**SOILS AND GEOLOGY REPORT ADDENDUM**  
US-441/STATE ROUTE 71 FROM  
US-411 (SR 35/ SR358) TO MACON LANE  
SEVIER COUNTY  
PROJECT NO. 78008-1244-14  
PIN NO. 104959.01

Executive Summary

Figure 2 Site 1 - Guardrail retaining wall to be removed.

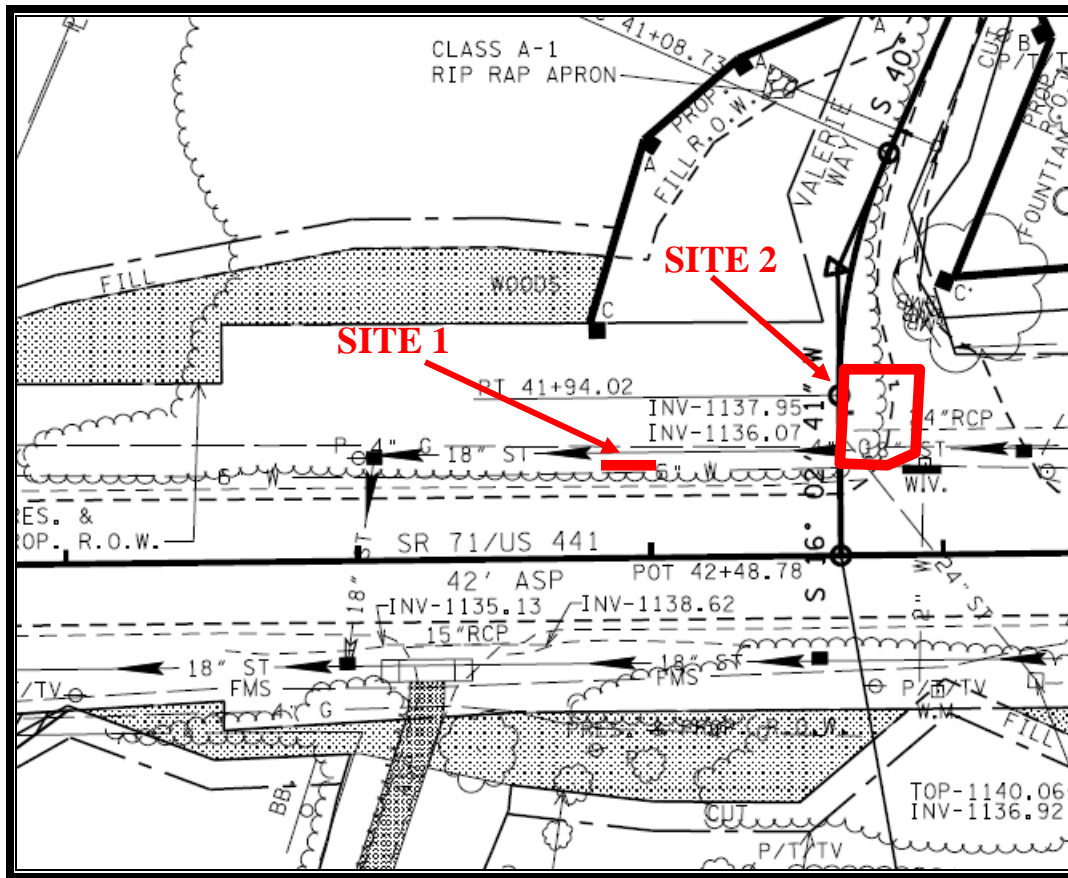
At Site 1 there is a small guardrail retaining wall (refer to Figure 2) approximately 12 ft. in length located from approximately Station 167+88 to Station 168+00 (refer to Figure 1) left of centerline of SR 71 (Chapman Hwy). It is recommended that the wall be removed before the embankment is widened.
